Subject: Thea Foss and Wheeler-Osgood Waterways Remediation Project
Operations, Maintenance, and Monitoring Plan

RESPONSE TO COMMENTS ON THE POST-CONSTRUCTION HYDROGEOLOGIC CONDITIONS REPORT

RESPONSE TO COMMENT ON THE TECHNICAL MEMORANDUM

**Figure 9
Groundwater Elevations Map
Intermediate Wells, October 2006**

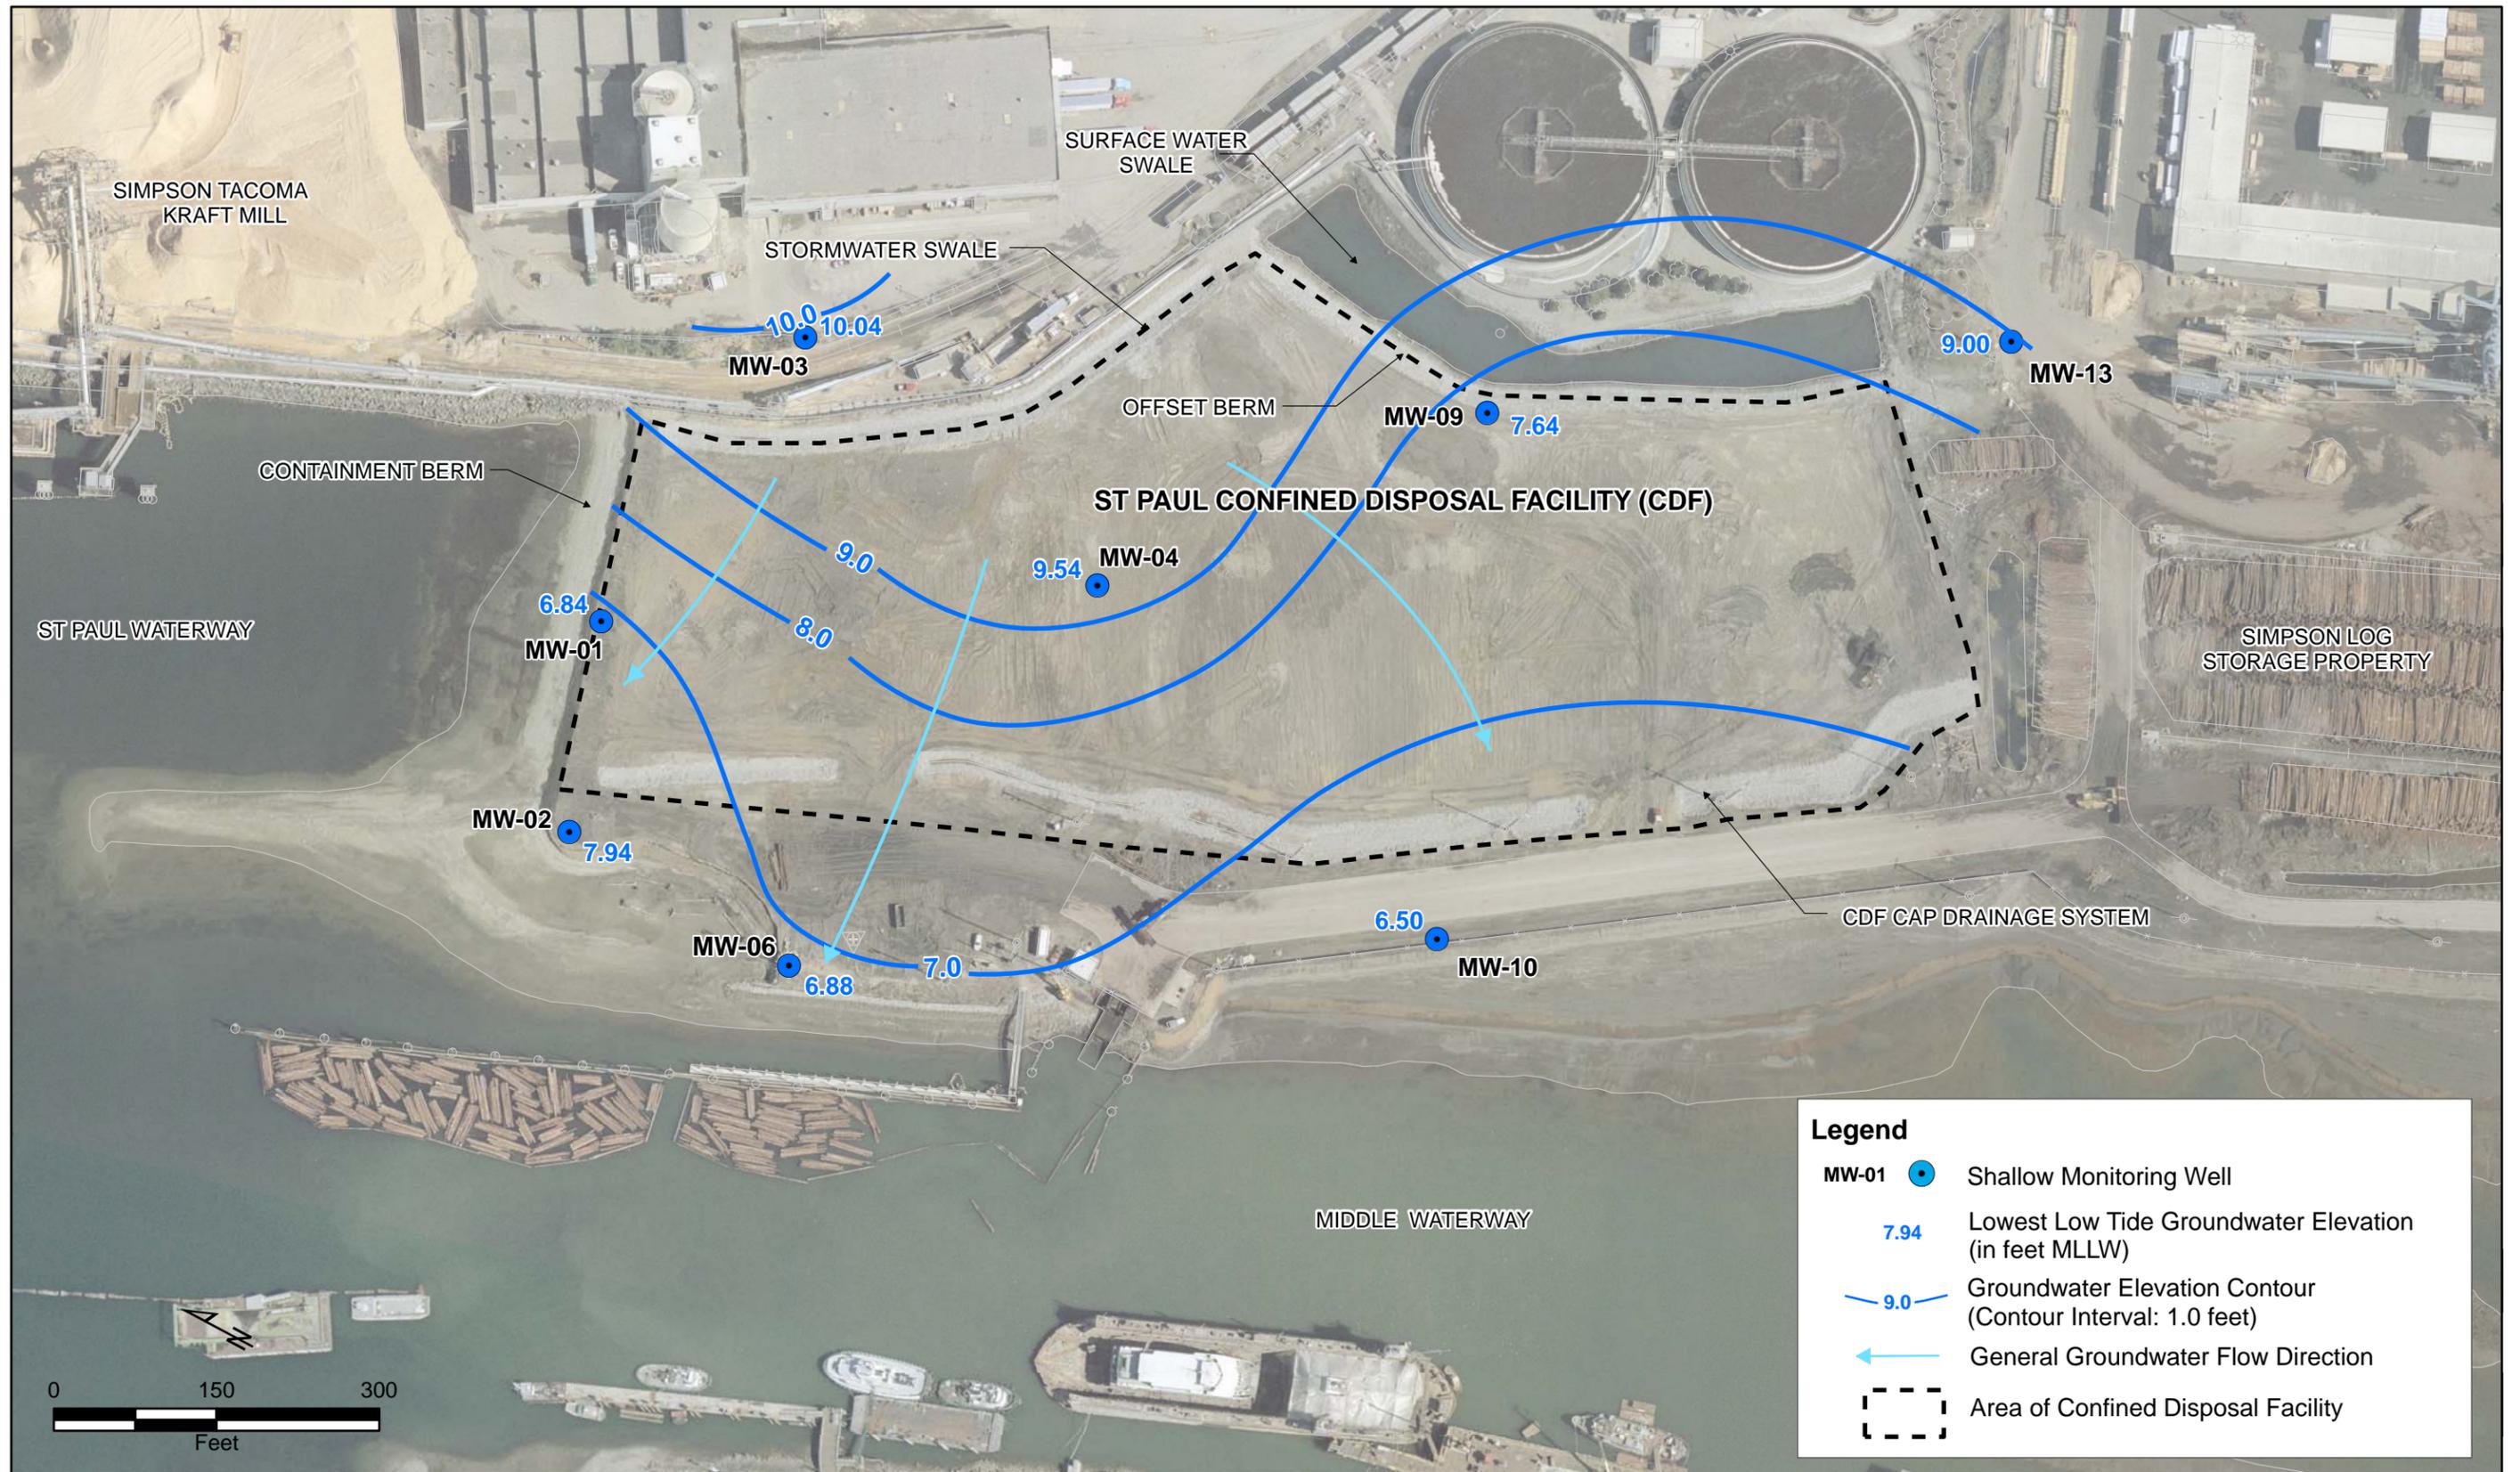
Comment No. 4. *Figure 9, Groundwater Elevations Map for Intermediate Wells – Groundwater flow direction arrows should always be perpendicular to potentiometric contours; therefore flow direction arrow on figure should be revised to be more southwesterly as opposed to westerly. This has implications for which parts of the CDF would actually be monitored by well MW-11.*

Response: Comment noted. Figure 9 has been revised so that the groundwater flow direction indicated by the arrow on the figure is in the southwesterly direction. A revised Figure 9 is provided with this response to comments. Upon approval, this figure will be provided to planholders to replace the existing Figure 9 in the report.

**Groundwater Elevations Map
Intermediate Wells, Highest High Tide
3:30 PM October 5, 2006**

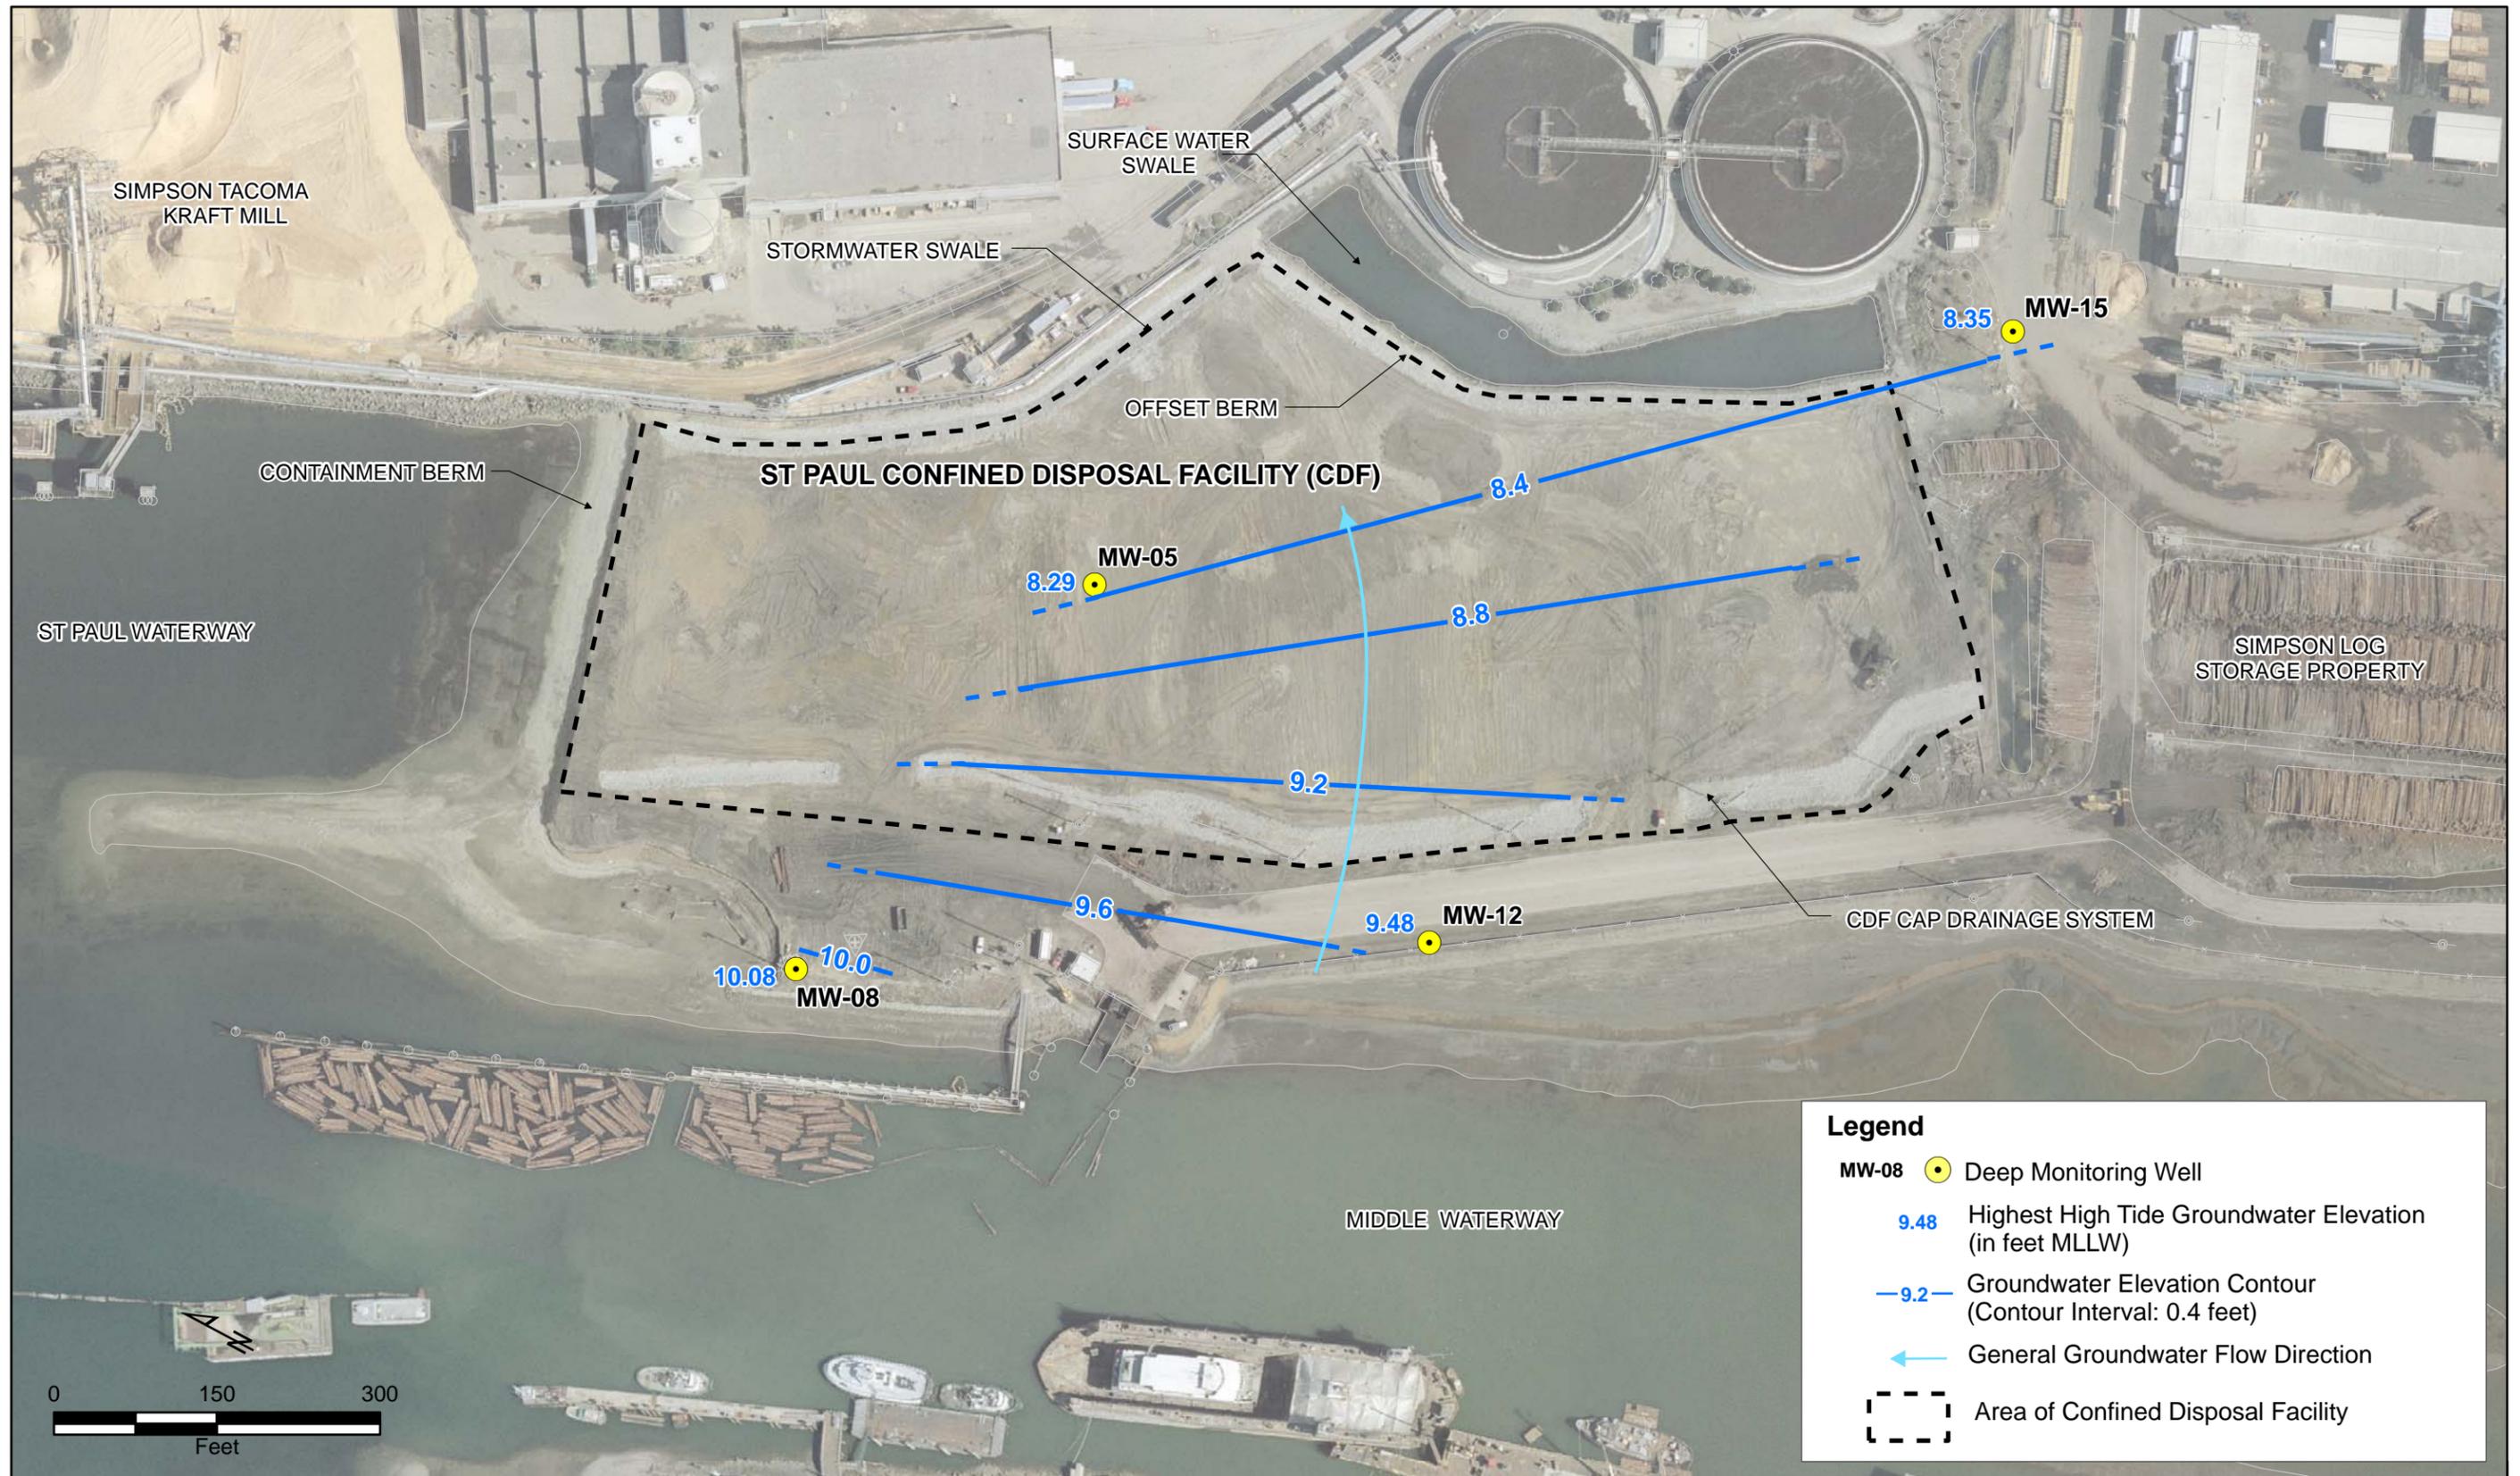
Comment No. 3. Section 3.4, Mean Groundwater Elevation, Gradients, and Flow Direction – Obviously seasonal changes in average groundwater gradient were not considered in this investigation due to its short duration. However, for completeness it would be appropriate to state this and possibly relate any information on seasonality gleaned from other studies within nearby Tacoma waterways if changes in flow direction or gradient magnitudes (horizontally and/or vertically) occur. Seasonal affects have the highest potential to affect gradient magnitudes (both horizontal and vertical) as opposed to averaged flow directions. Also, include representative maps showing high and low tide flow directions.

Additional figures have been prepared that present the groundwater flow directions at the lowest low tide and the highest high tide for each of the well intervals – shallow, intermediate, and deep. The additional figures are provided with this response to comments.

Log of Soil Boring and Well Construction B01/MW-01

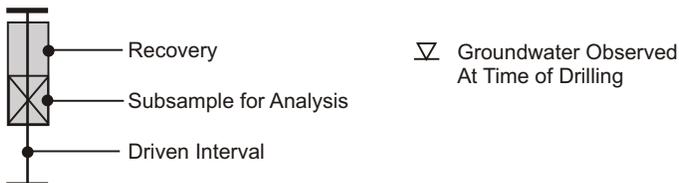
Comment No. 5. Boring/well logs are missing for MW-01 through MW-04.

Response: Comment noted. Copies of the boring/well logs for MW-01 through MW-04 are provided with this response to comments. The boring logs for MW-01 through MW-04 must have been inadvertently left out of the copy of the report provided to the Corps in the process of reproduction.
